**To:** Planning Committee **Date:** June 28, 2011  
**From:** Brian J. Jackson **File:** RZ 10-536067  
 Director of Development  
**Re:** **Application by Gagan Deep Chadha & Rajat Bedi for Rezoning at 9511/9531 and 9551 No. 3 Road from Two-Unit Dwellings (RD1) & Single Detached (RS1/E) to Low Density Townhouses (RTL4)**

## Staff Report

# MULTI-FAMILY RESIDENTIAL DEVELOPMENT @ 9511, 9531, 9551 NO 3 ROAD, RICHMOND, BC

**LOWER SITE PLAN**

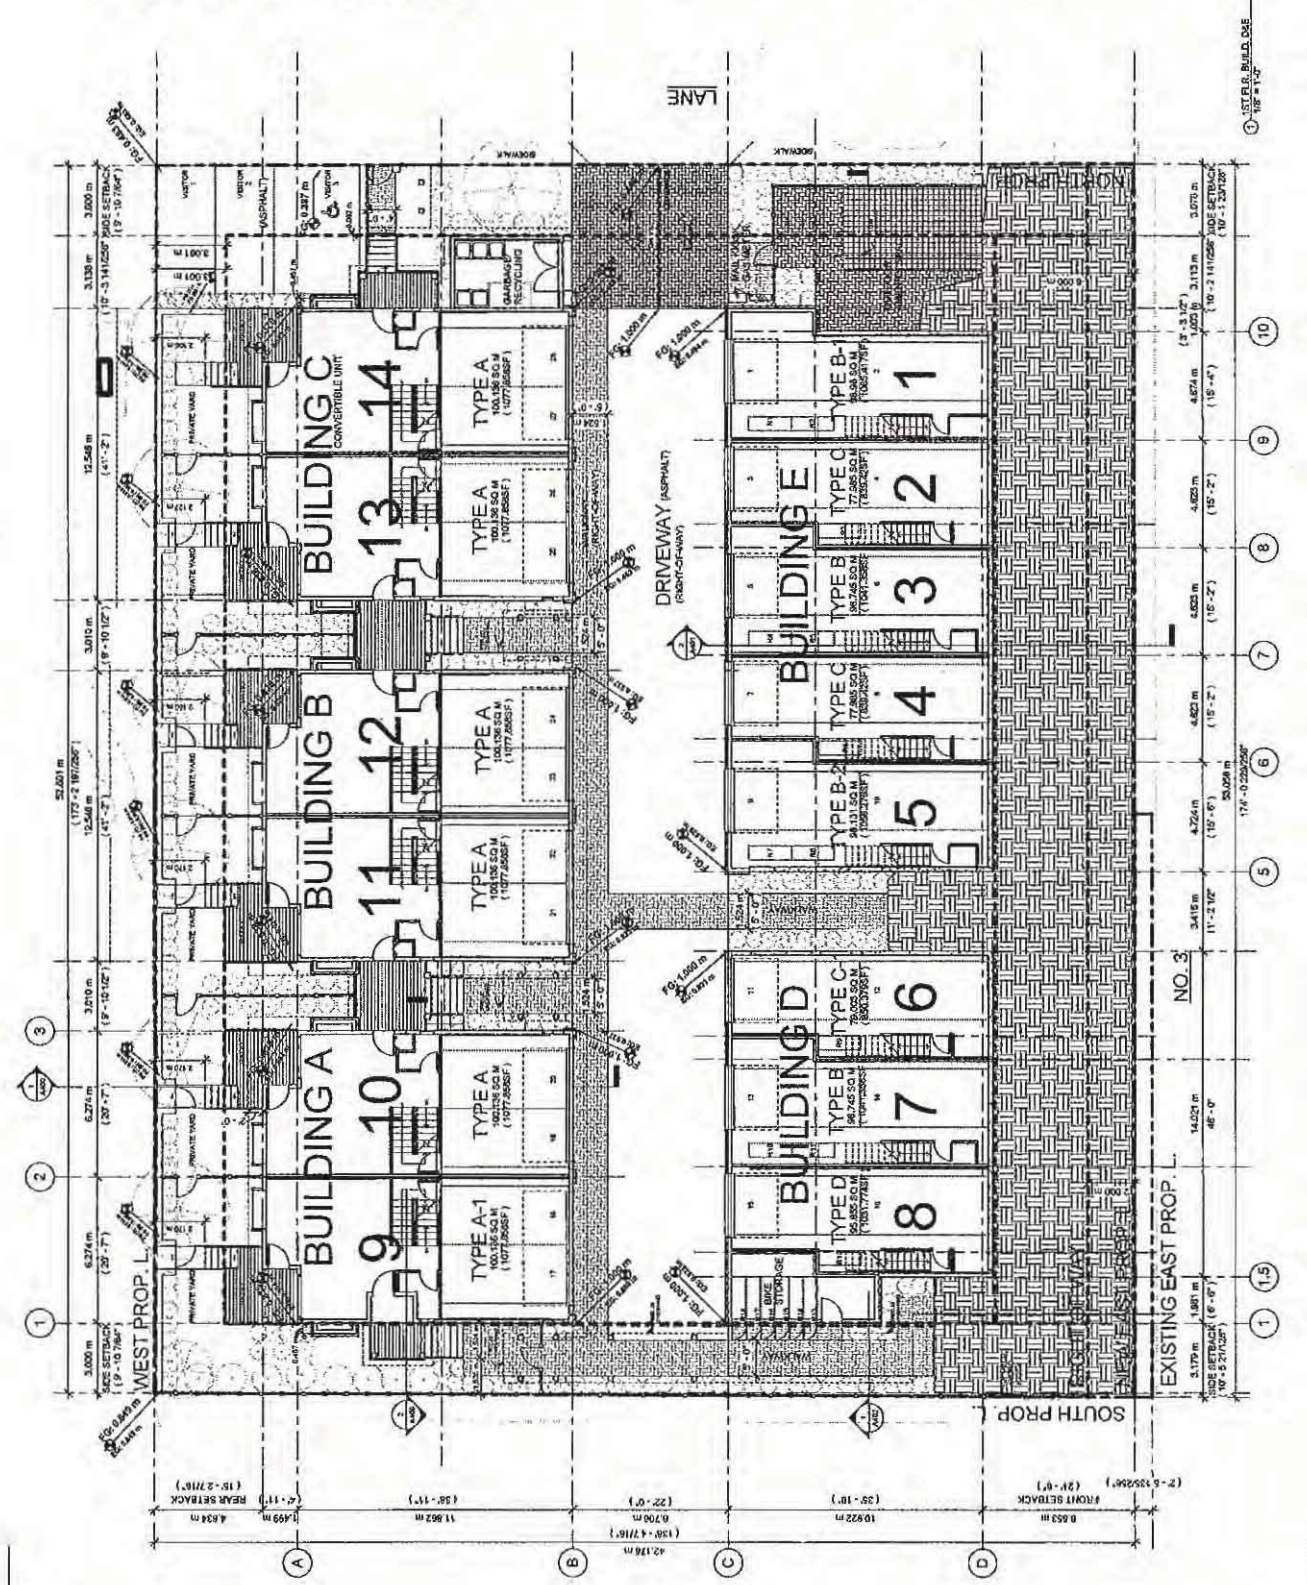
- Improvements to lot grading and its impact on the streetscape elevation along No. 3 Road (including entry stair design), and within the outdoor amenity area;

- Improvements to the visitor parking area to better define and integrate it within the development site (e.g. grasscrete surface treatment, slight shift to the east to enable landscaping along the west property line);

**NORTH / EAST (BUILD. D/E) ELEVATIONS**

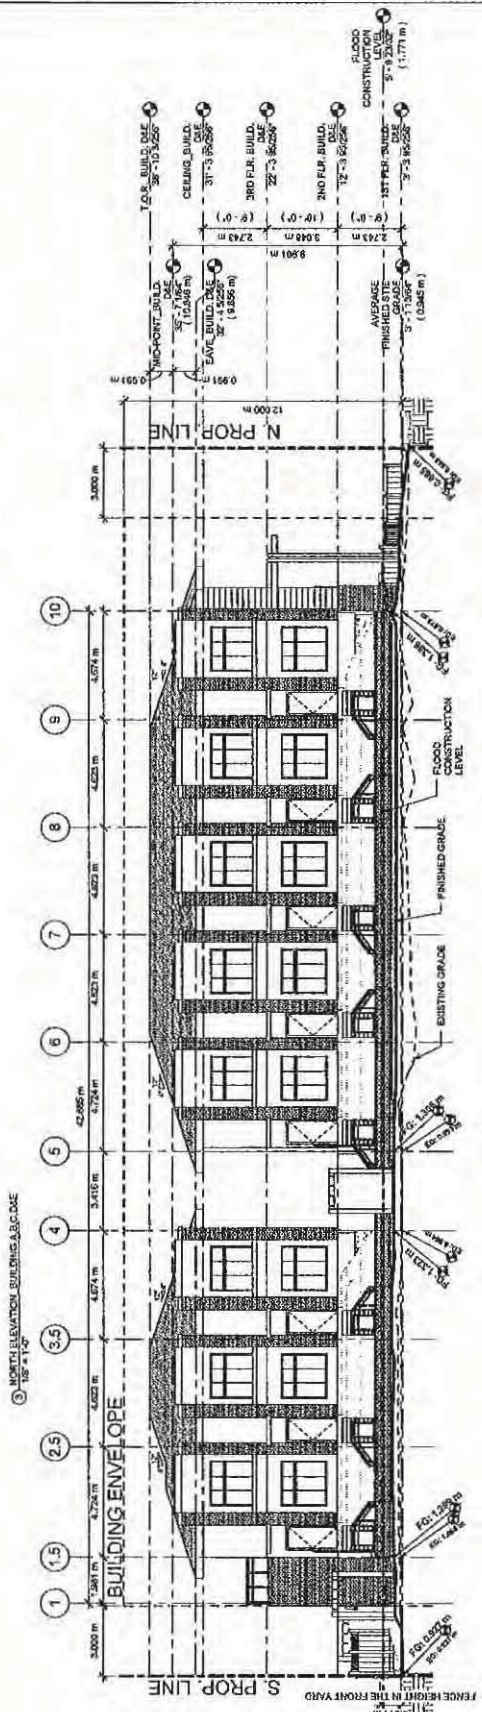
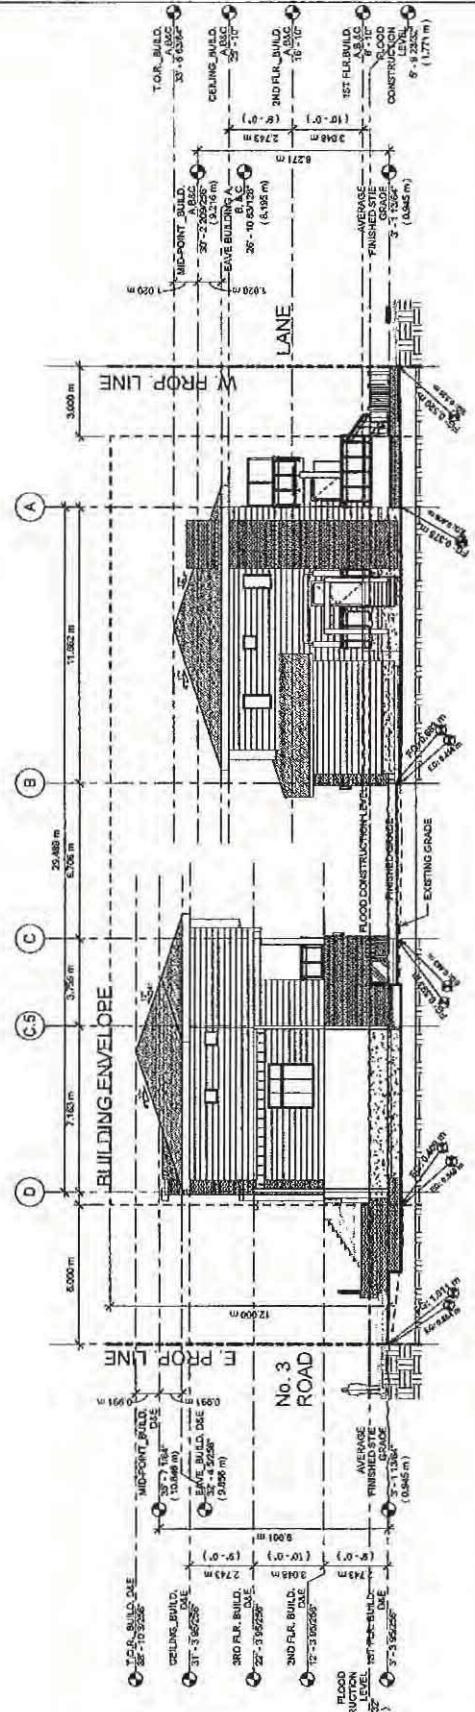
- Opportunities to reduce the massing of the end units;
- Opportunities for improvements to the massing and design of exposed architectural elevations to address potential adjacency concerns (e.g. end-unit massing, large expanses of brick walls on side elevations, bike storage locker doors, garbage and recycling enclosure height etc.)

- Opportunities for refinements to all architectural elevations through the addition of window openings, through variation in exterior materials, and to break up the appearance of the row of garage doors along the internal drive-aisle;

TREE SURVEY

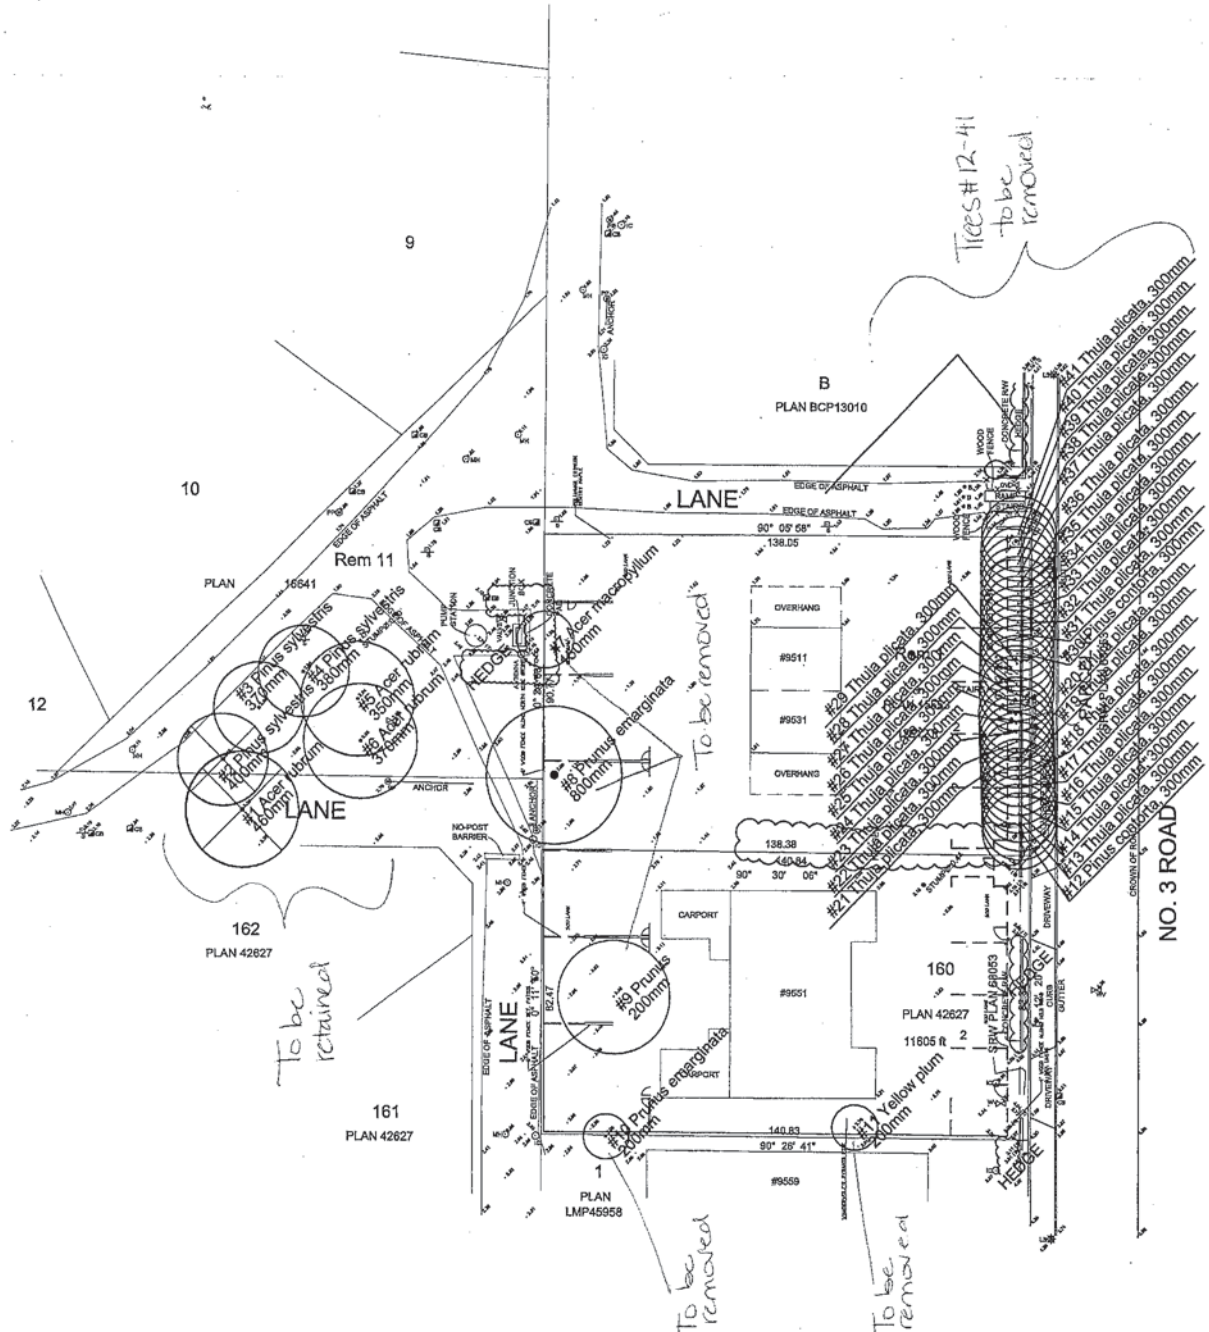
- Removal of the four (4) bylaw-sized trees (Trees # 7, 8, 9, 11) and the hedgerow comprised of 30 specimens (Trees # 12 to 41) from the subject site;
- Removal of Tree # 10 located on the shared south property line of the site, with 9559 No. 3 Road; and
- Retention of six (6) bylaw-sized trees (Trees # 1 to 6) on the adjacent city-owned parcel to the west.

- Trees # 7, 8, 9, 11 are all in poor condition (dead upper canopy, leaning structure, basal cavity, inclusions, fungal growth, hollow trunk etc);
- The hedgerow containing Trees # 12 to 41 has been previously topped at 3.6 m (12 ft) above the ground and has weak branch attachments at the old topping site making them prone to failure. 50% of the trees in the hedgerow are dead. The base of the hedgerow is also located approximately 1 m (3 ft) below the existing crown of the road and conflicts with proposed development plans to achieve the required Flood Construction Level;

- Tree # 10 is in very poor condition, with significant rot at the basal flare and major limbs, and damage to the canopy from past hydro line clearance pruning; and,

- Trees # 1 to 6 on city-owned property are located approximately 15 m away from the west property line of the subject site, and are not anticipated to be impacted by the proposed development. These trees are required to be retained.

Prior to demolition of the existing dwellings on-site, tree protection fencing must be installed to City standard around the city-owned parcel to the west of the subject site, which contains protected trees (Trees # 1 to 6). Tree protection fencing must remain in place until construction and landscaping on the future lots is completed.

To ensure survival of Trees # 1 to 6, the applicant must submit a security in the amount of \$6,000 prior to final adoption of the rezoning bylaw (reflects the 2:1 replacement tree ratio at \$1,000 per tree). The City will release 90% of the security after construction and landscaping on the future lots is completed and a landscape inspection is approved. The remaining 10% of the security will be released one (1) year later, subject to inspection, to ensure the trees have survived.

The tree replacement ratio goal identified in the Official Community Plan is 2:1. Given the four (4) bylaw-sized trees and the hedgerow proposed to be removed from the site, staff recommend that a total of 16 replacement trees be planted and maintained on-site. The applicants have agreed to this recommendation. At Development Permit stage, the final landscape plan attached must include the 16 replacement trees and a letter of credit for the proposed landscaping is required to be submitted by the applicants.
